Informal Document N° 20

(30th GRSP, 3-6 December 2001,
agenda item 1.4)

Draft Amendments To Regulation No. 17:
(Strength of Seats)

Figure 2

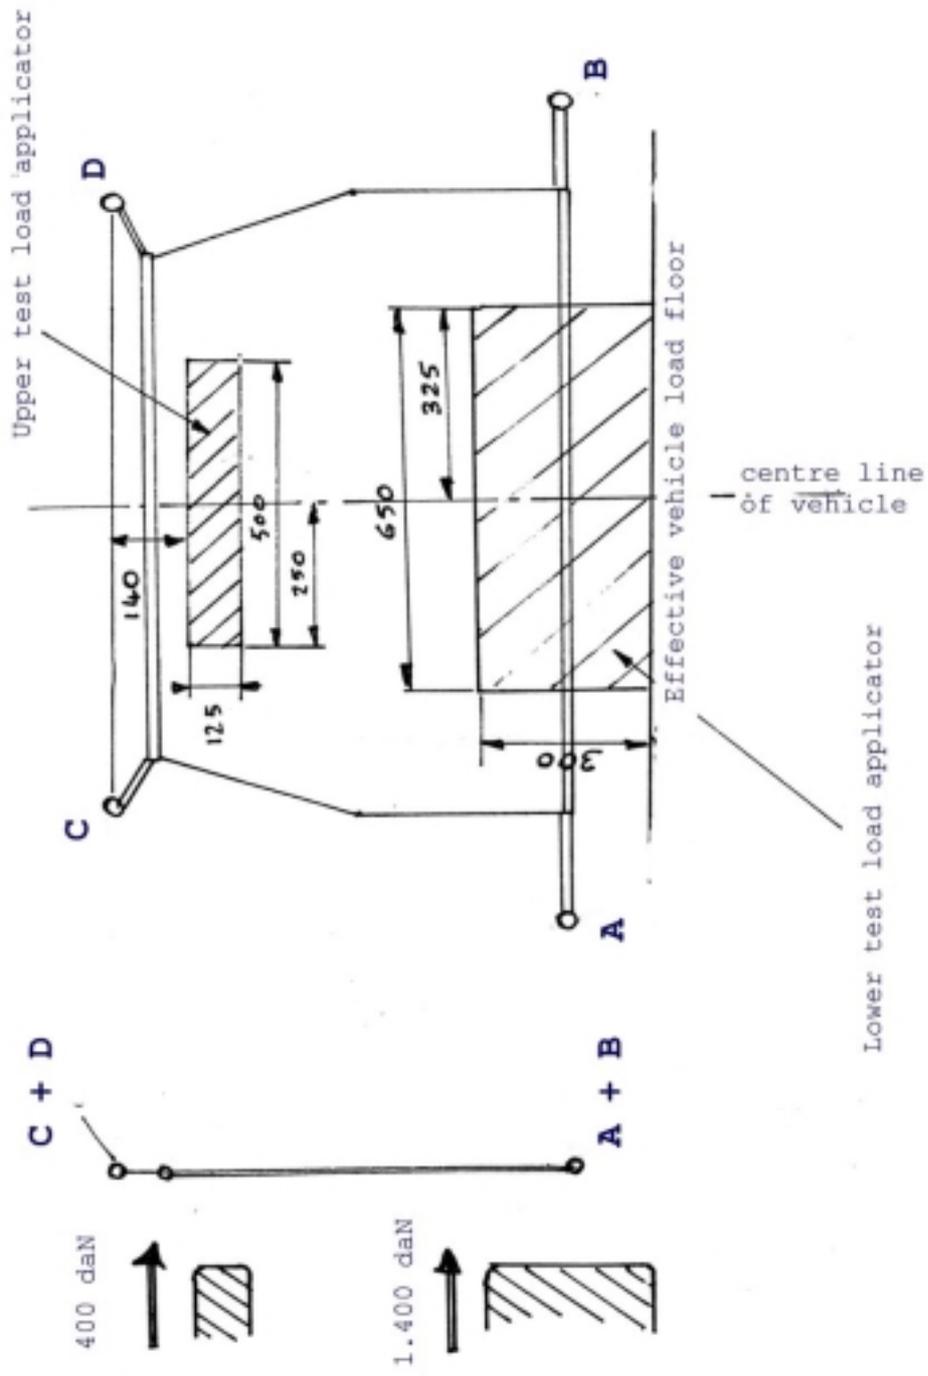
2. Full Partitioning System (Type B) Load Application. Referring to figure 2 The upper test load applicator E consists of a rigid panel 500mm.X 125mm. with all edges and corners rounded to a radius of 20mm. This is positioned relative to the partitioning system as shown in figure 2. The lower test load applicator F consists of a rigid panel 650mm. X 300mm. with all edges and corners rounded to a radius of 20mm. This is positioned relative to the partitioning system as shown in figure 2. Simultaneously the load applicators E and F are to be pressed into the partitioning system until the force applied to the upper applicator E reaches a value of 400 daN and the force applied to the lower applicator F reaches 1,440 daN. When the load of each applicator reaches its maximum value the load is to be released. The speed of application of the load is to be not less than 100mm. per minute in all cases.

Diagram of an apparatus to test
the strength of partitioning systems

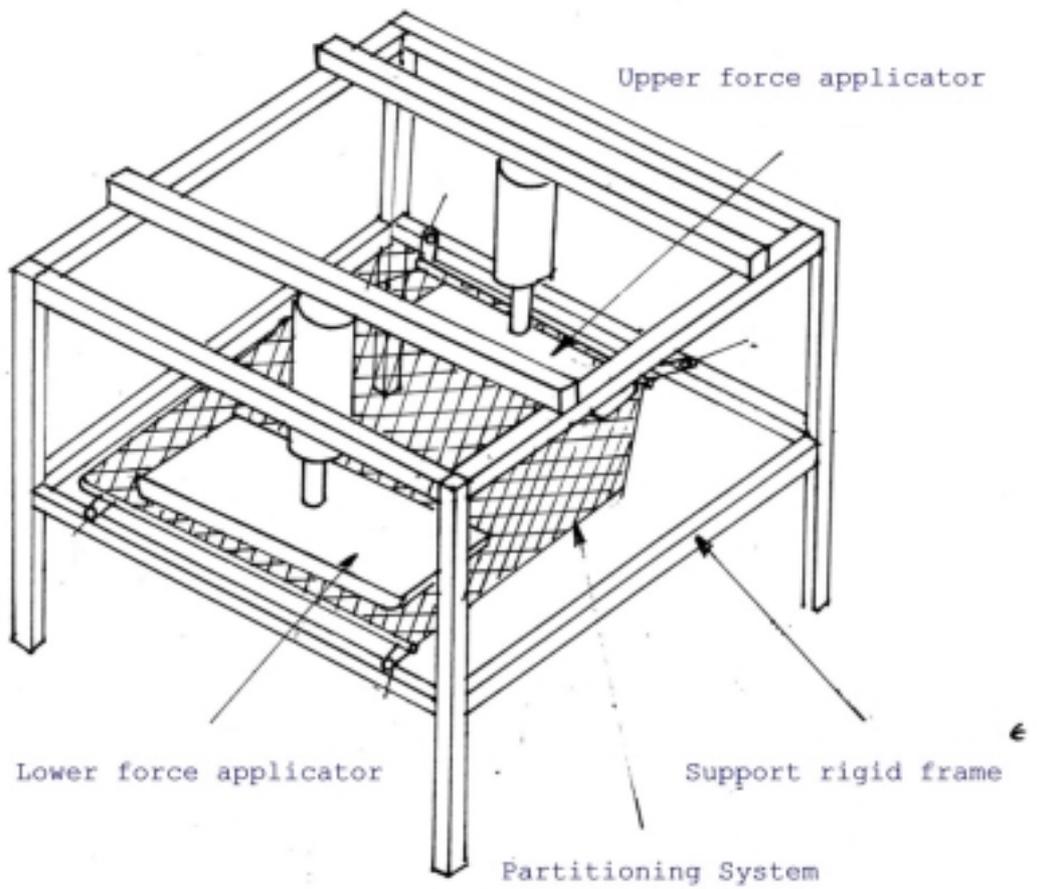
Annex 11 Diagram of an apparatus to test the strength of partitioning systems.
